HARVEST VALLEY ESTATES

Re: S/D 97-41 -- Final Plat of HARVEST VALLEY ESTATES

Re: S/D 97-41 - Revised Preliminary Plat of HARVEST VALLEY ESTATES

CASE NUMBER: S/D 97-41 HARVEST VALLEY ESTATES

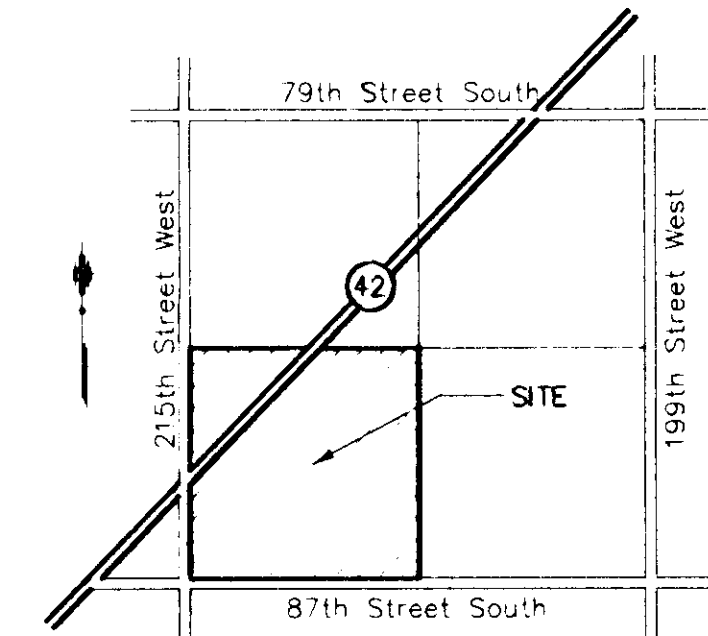
- C. The appropriate departments and affected agencies should comment on the suitability of the interior street layout, the number of intersections with K-42, and proposed access control. The word "complete" should be removed from any reference to access control which allows access. It cannot be complete access control if access is allowed. Also, should accel/decel and/or left-turn lanes be provided along K-42 at approved points of access?

For Lot 9, Block 1, 100 feet of complete access control shall be dedicated along the southern frontage of the lot along 215th Street West. For Lot 3, Block 2, complete access control shall be dedicated for the north 100 feet and the south 100 feet of frontage along 215th Street West.

County Engineering has commented that the drainage concept is acceptable. The drainage easements shall be shown on the final plat as a floodway reserve, and be a minimum width of 50 feet. The drainage easement on Lot 17, Block 2 shall be realigned to line up with the culvert under 87th Street South.

T. On the final plat tracing, the Chair of the MAPC should read Richard E. Lopez. The Deputy should read Michael D. Hurtt. The Chair Pro Tem should read Paul W. Hancock. Melody C. Miller should be spelled correctly.

The final plat includes a revised street layout as requested by County Engineering.

The final plat includes the requested access controls. However, Lot 3, Block 2, located on the southwest corner of the plat, now denotes access to 87th Street

The final plat includes the requested revisions by County Engineering. On the final plat tracing, the centerline of the floodway reserves should be denoted by a dashed line. The platting text should note the creation of the Floodway reserves. County Engineering needs to comment on the status of the applicant's drainage plan. The drainage plan has been approved although revisions need to be made to minimum building pad elevations. County Engineering also requires a letter of map revision regarding the floodway located within the plat.
